ENGINEER'S CERTIFICATION FOR STAPLES OFFICE SUPERSTORE, (F-21/ RE: D012), ENGINEER'S STAMP DATED 2/21/00, CERTIFICATION DATED 7/10/2000.

RE: STAPLES OFFICE SUPERSTORE - MONTGOMERY @ EUBANK (F21-D12).

GRADING AND DRAINAGE PLAN FOR BUILDING PERMIT AND SO#19

Re: Site Plan submittal for building permit approval for Staples, 9701 Montgomery N.E., Security Federal

Transmitted herewith is a copy of the approved drainage plan for the referenced project incorporating the SO #19 design.

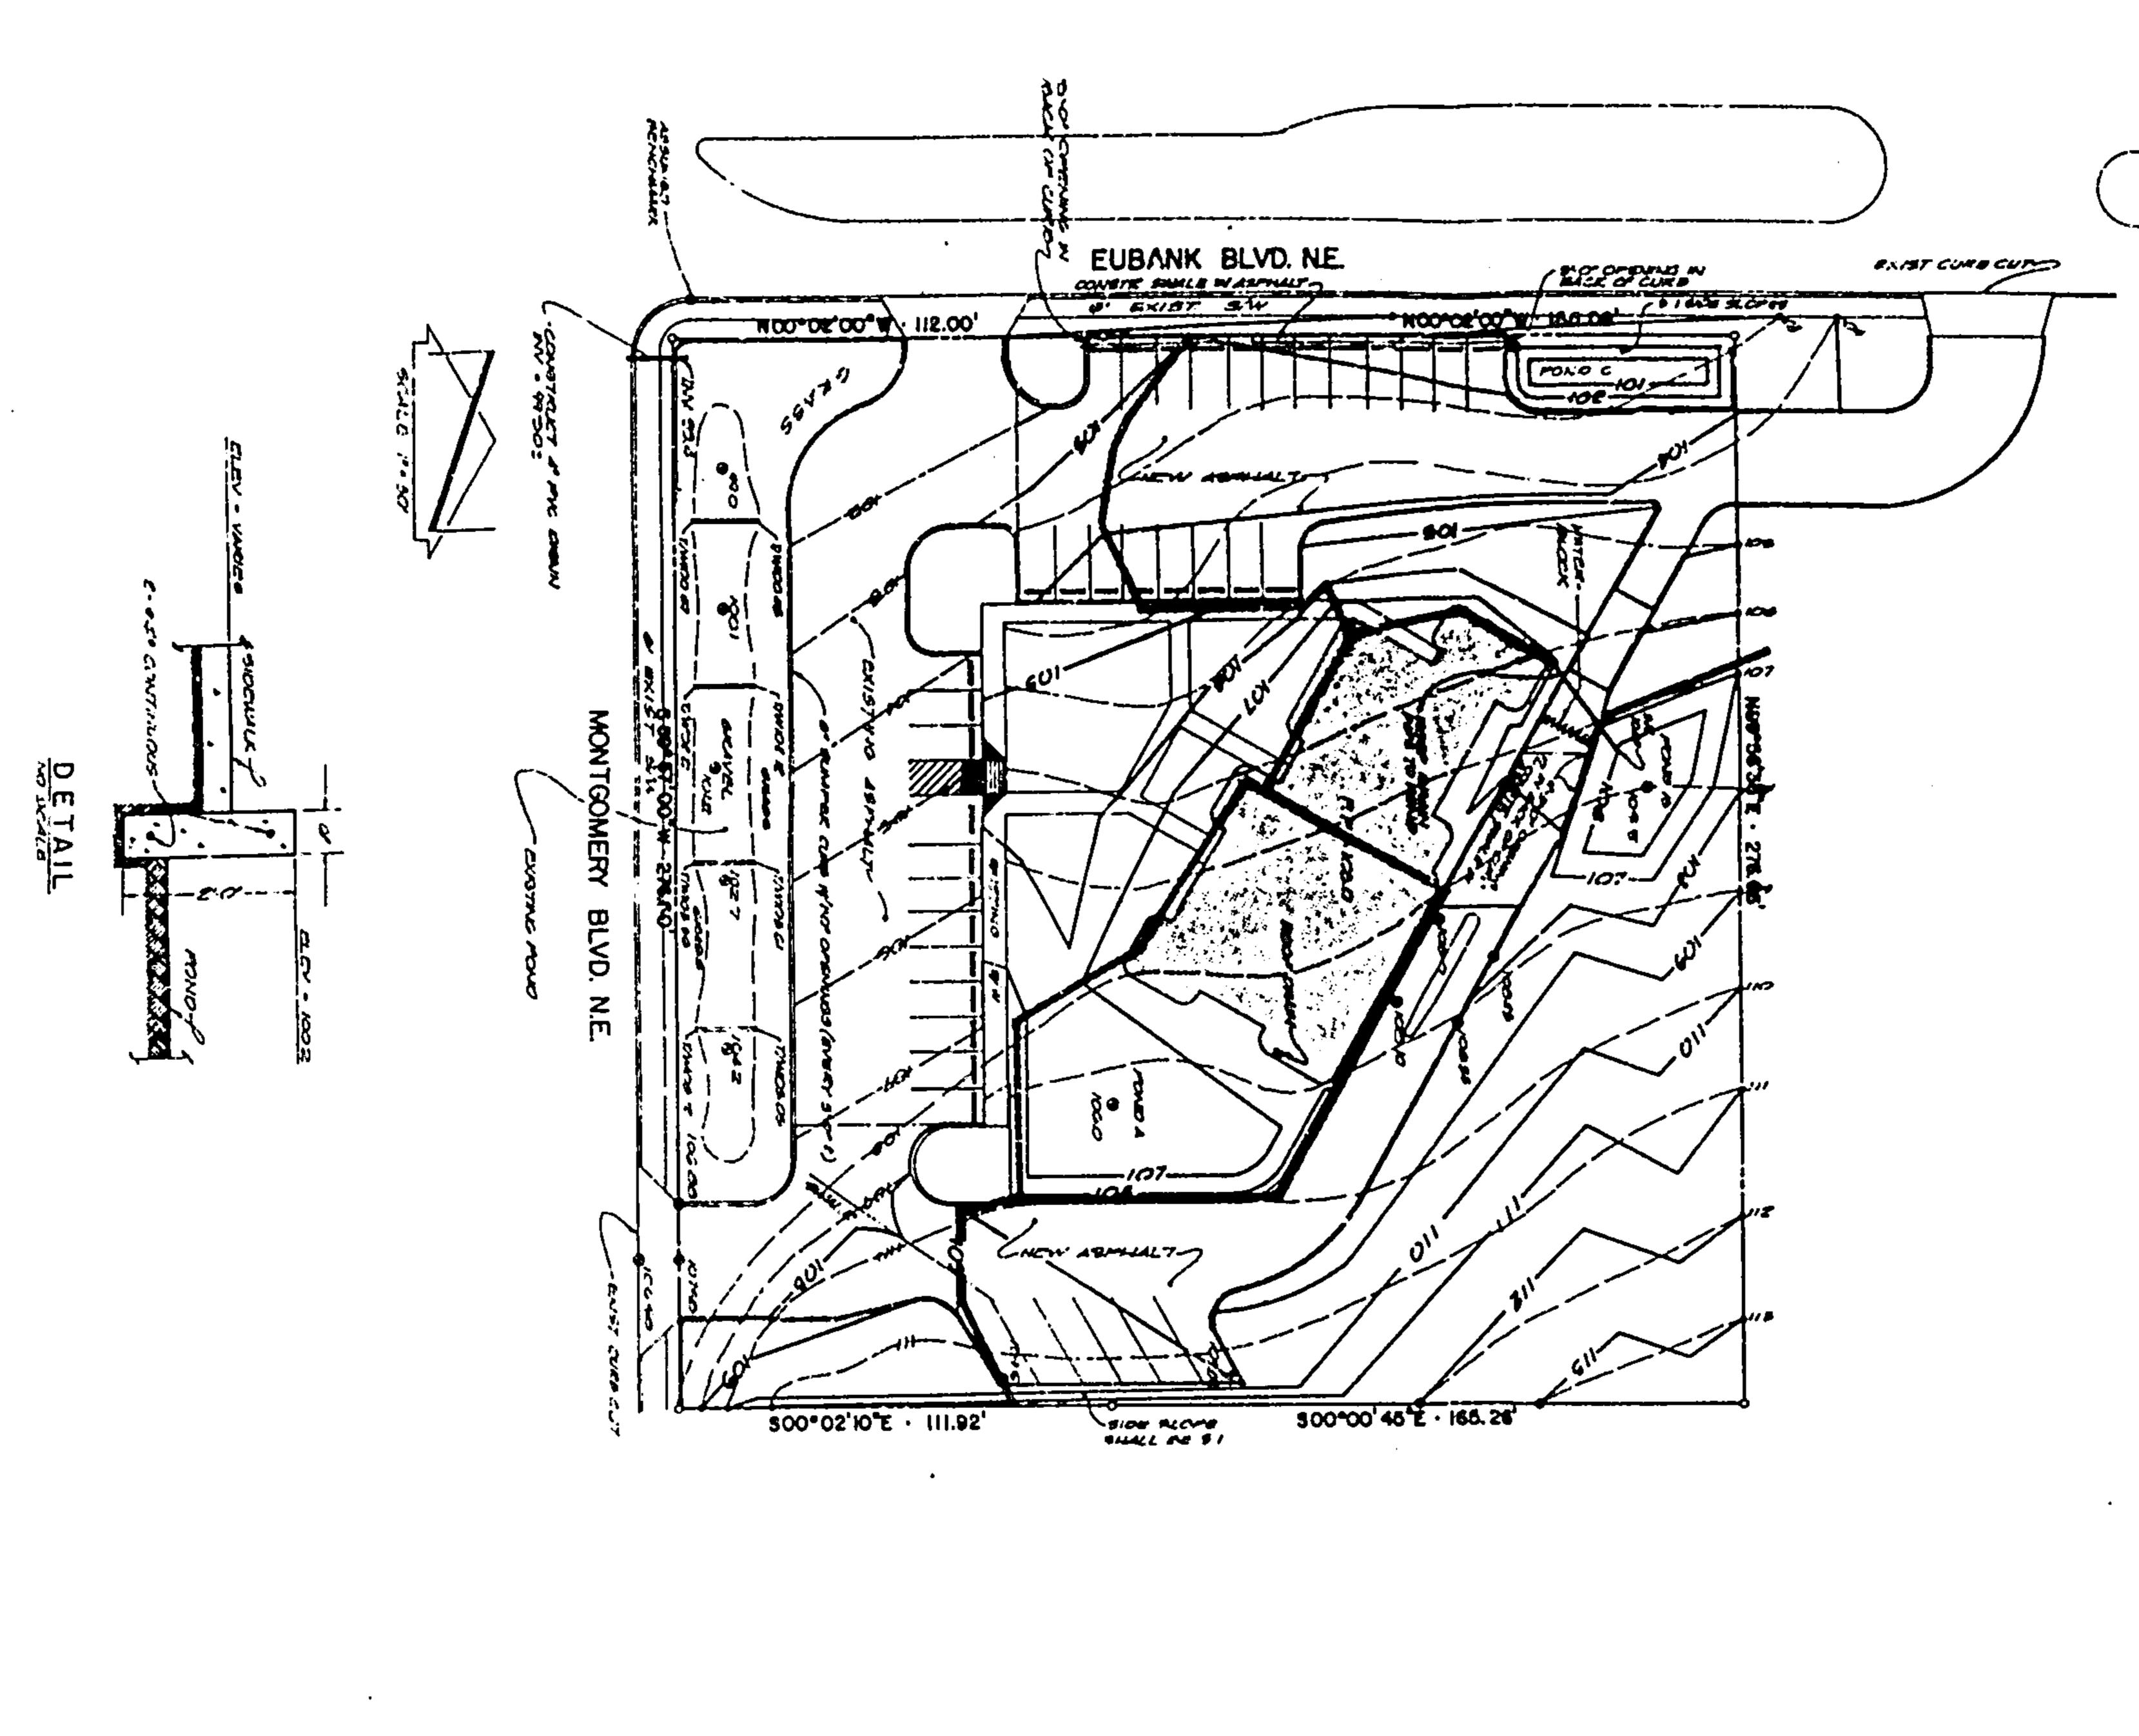
Add the standard SO#19 notes and signature block to cover the tie-in to the existing catch basin on Eubank Boulevard. Provide a second coppy of the G&D Plan for that process.
